**Municipal Planning Commission
AGENDA
Monday, October 7, 2024 — 6:30 p.m.
Bartlett City Hall Assembly Chamber**

1. Stelling Planned Development, 4570 Billy Maher Road (David Bray, the Bray Firm)

PLANNING COMMISSION
Monday, October 7, 2024 - 6:30 P.M.
Bartlett City Hall Assembly Chamber
Staff Comments

1. Stelling Planned Development, 4570 Billy Maher Road (David Bray, The Bray Firm)

PRELIMINARY SANITARY SEWER PLAN

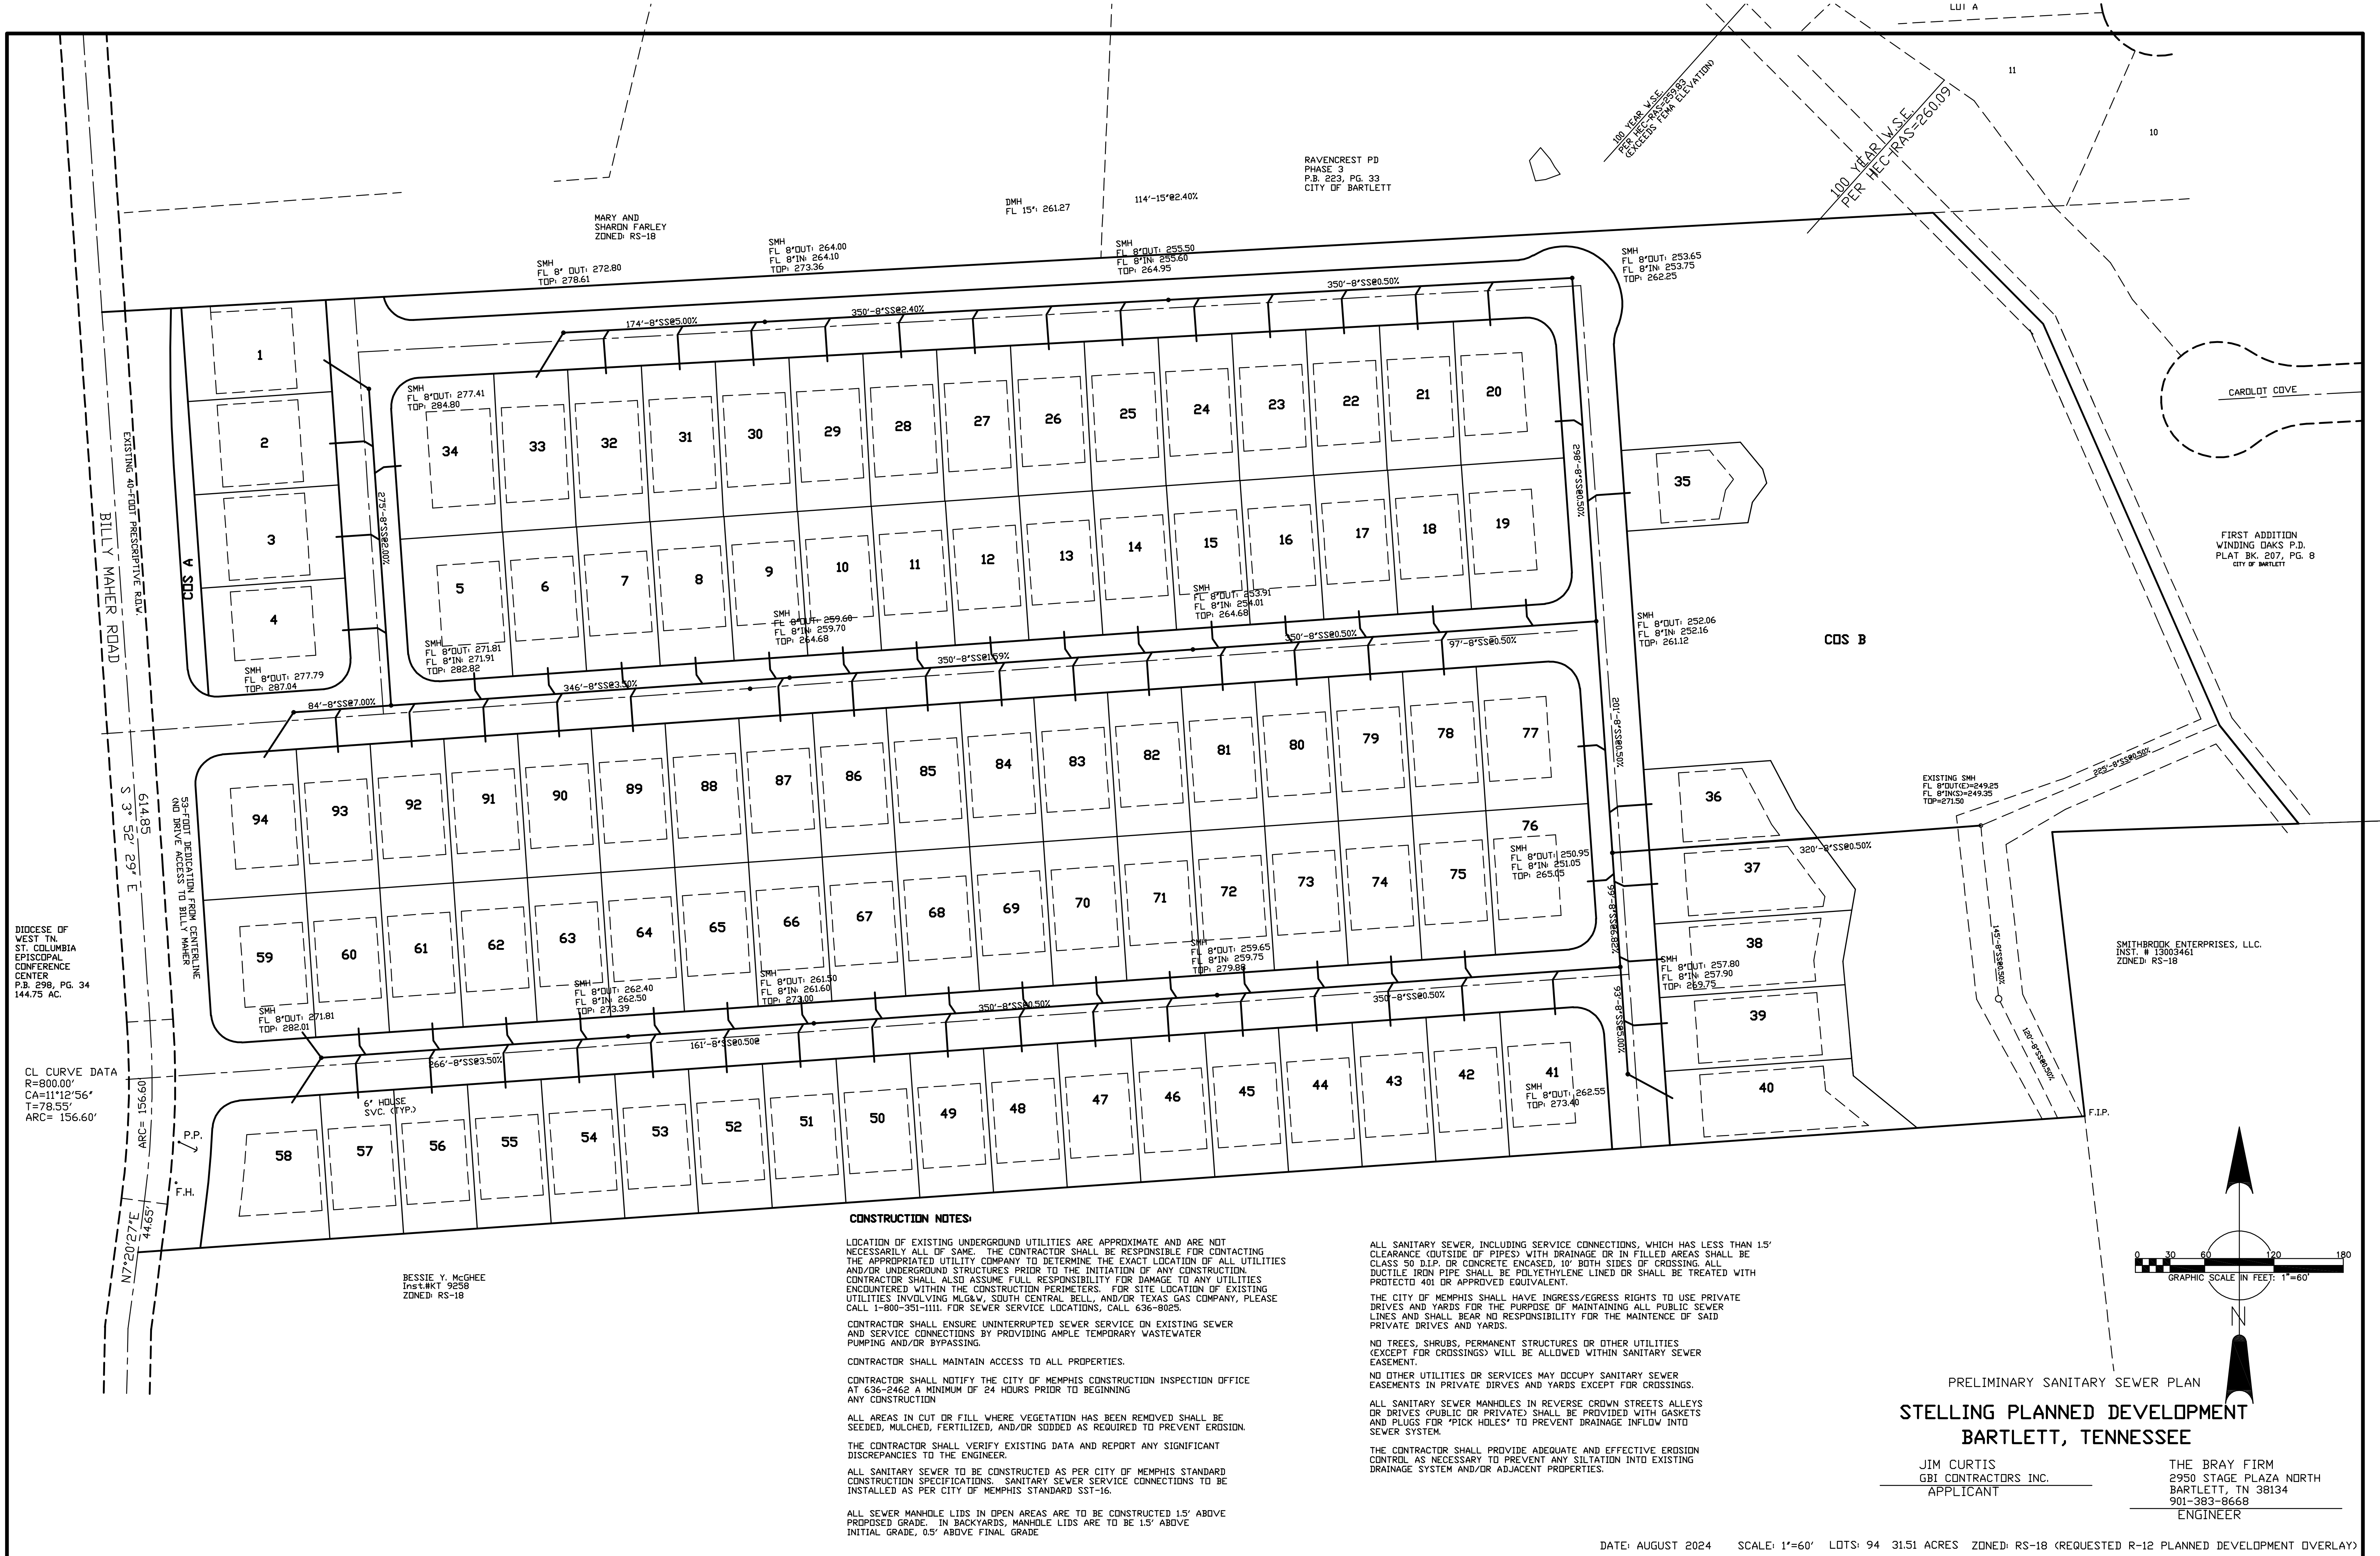
19. Eliminate one of the services to lot 20.
20. Change construction notes to reflect information for the City of Bartlett.
21. A structure and pipe table is required.
22. A plan and profile is required.
23. This PD will potentially discharge into the Billy Maher Sewer pump station. A flow analysis must be conducted to see if this pump station and/or forcemain must be upgraded.

PRELIMINARY EROSION CONTROL PLAN
**STELLING PLANNED DEVELOPMENT
BARTLETT, TENNESSEE**

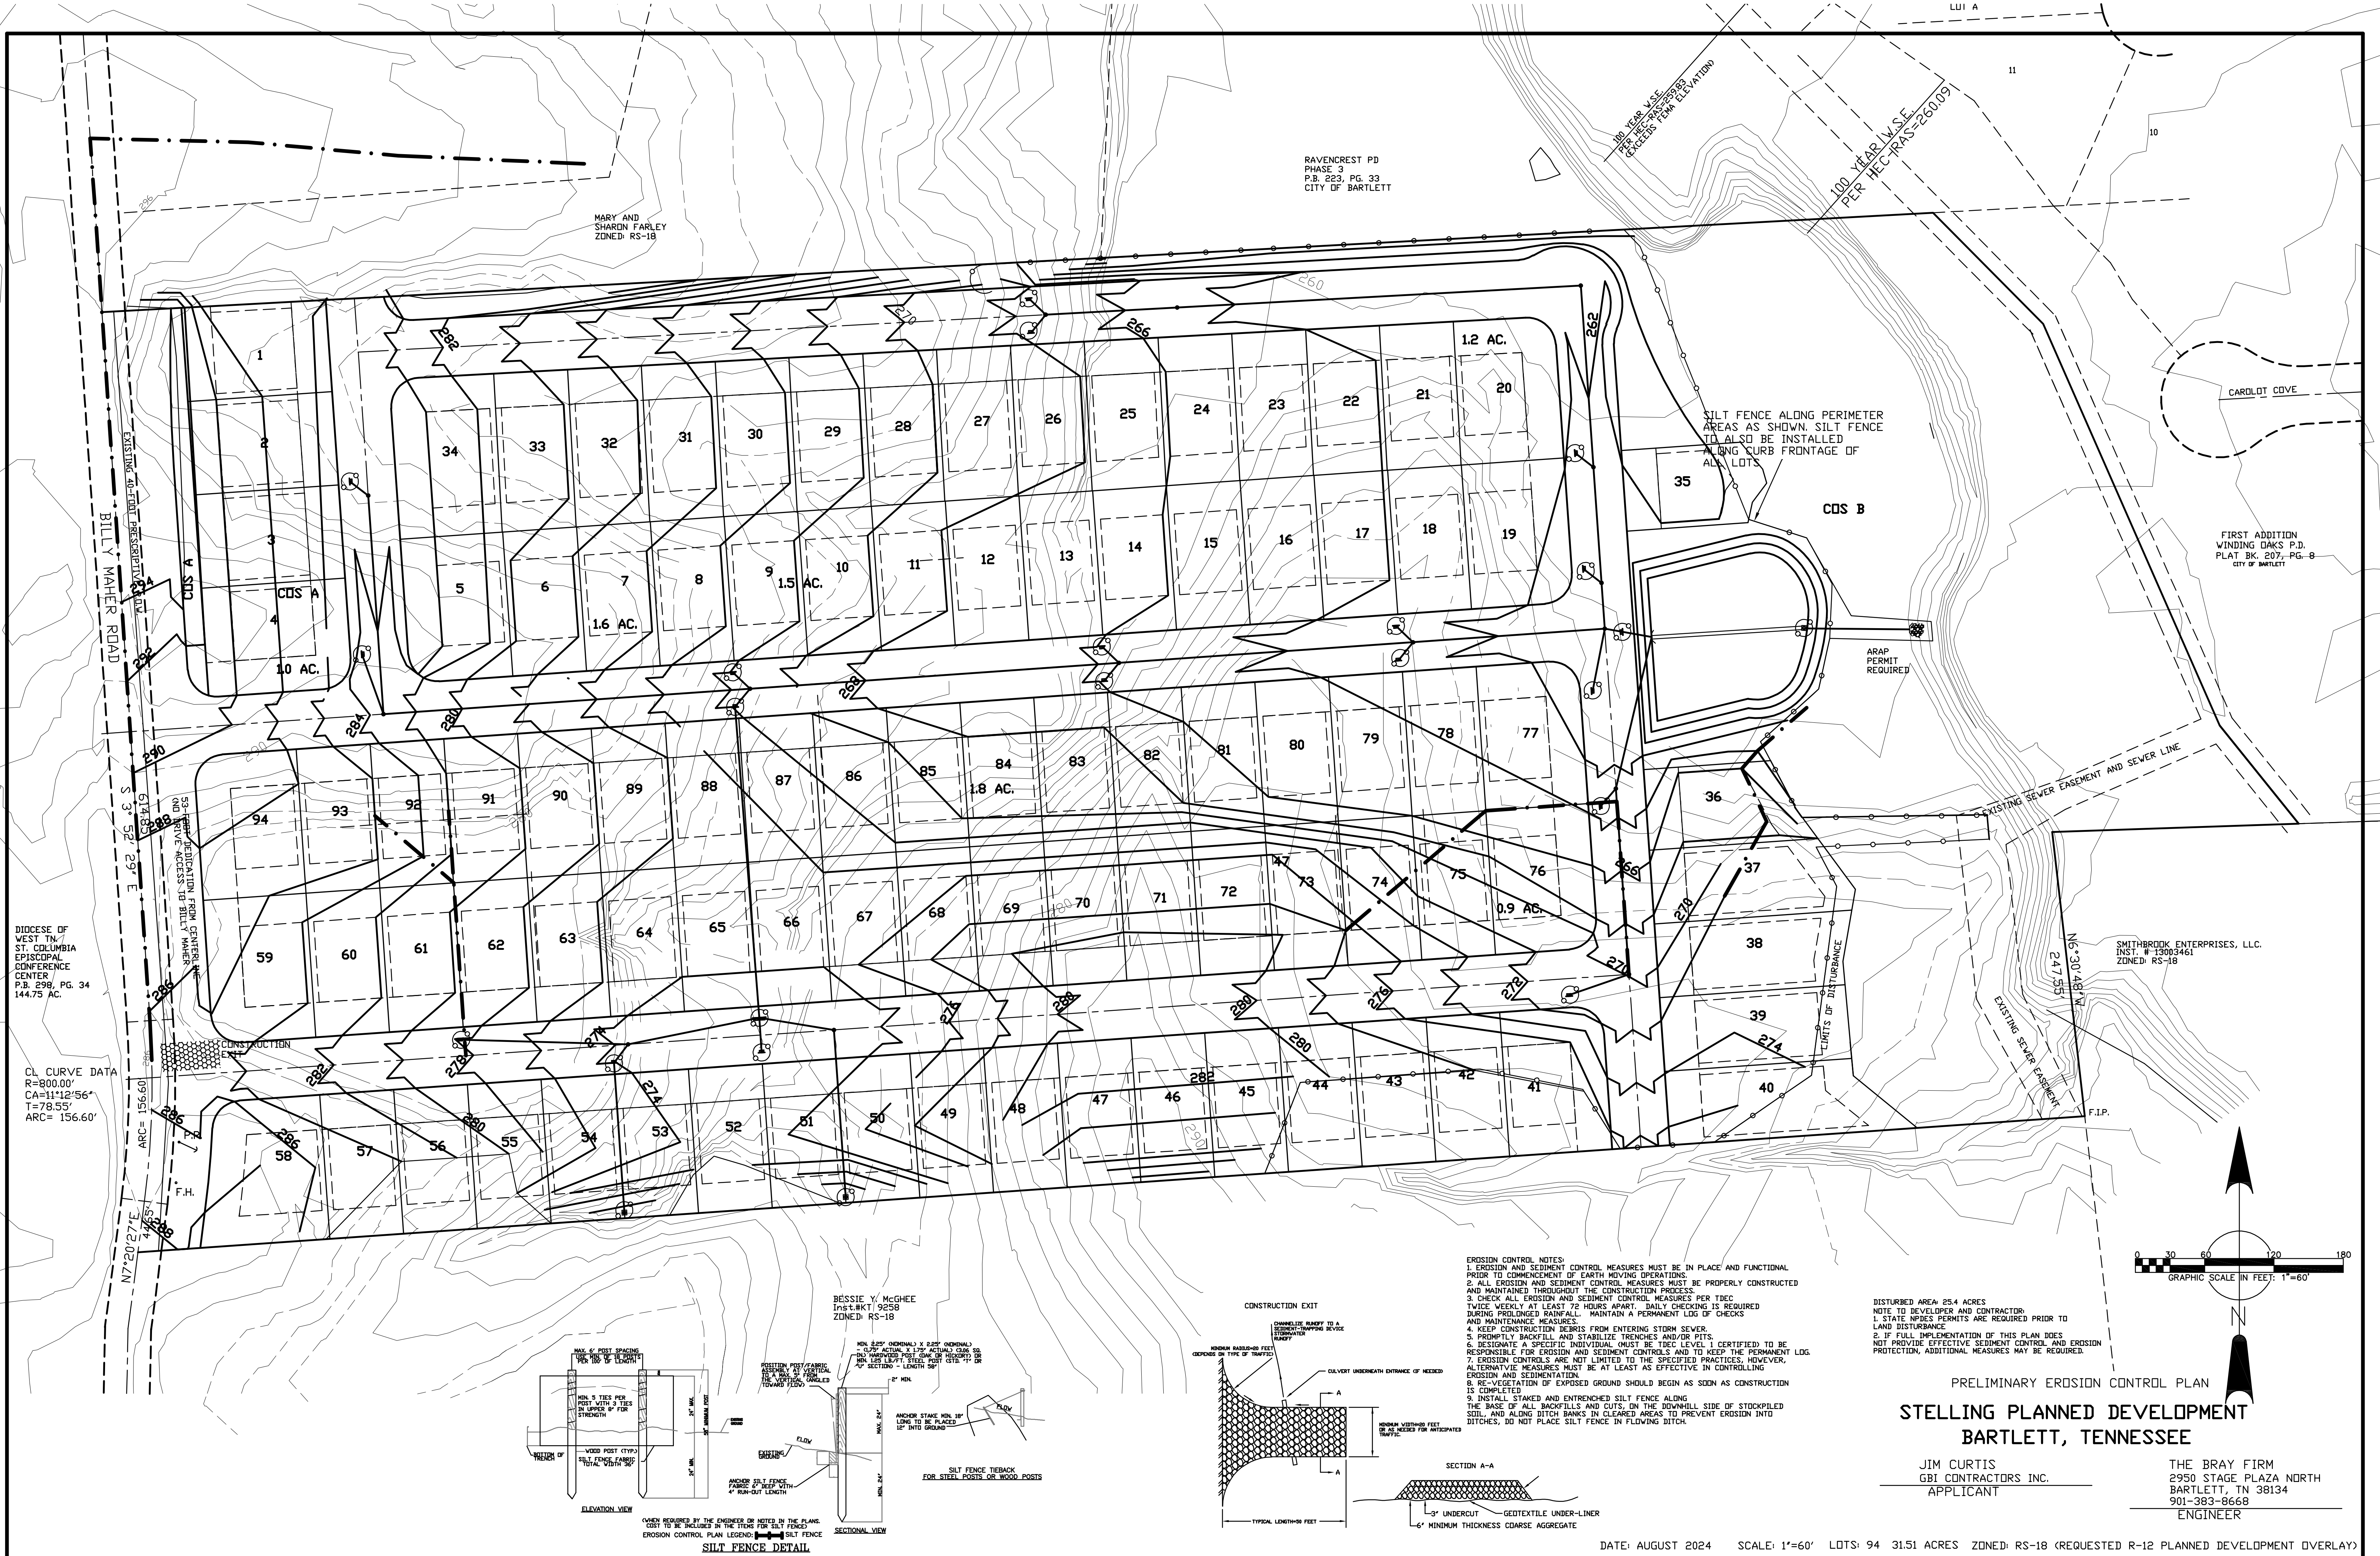
24. The engineer shall provide a copy of the SWPPP (Storm Water Pollution Prevention Plan) that has been or will be submitted to TDEC (Tennessee Department of Conservation).
25. Prior to any work being started, an NOC (Notice of Coverage) from TDEC must be received and a copy submitted to the City of Bartlett.
26. Metal posts with wire-backed fence are required on the proposed silt fences.
27. Details for inlet protection are required.
28. The TDEC permit number shall be shown.
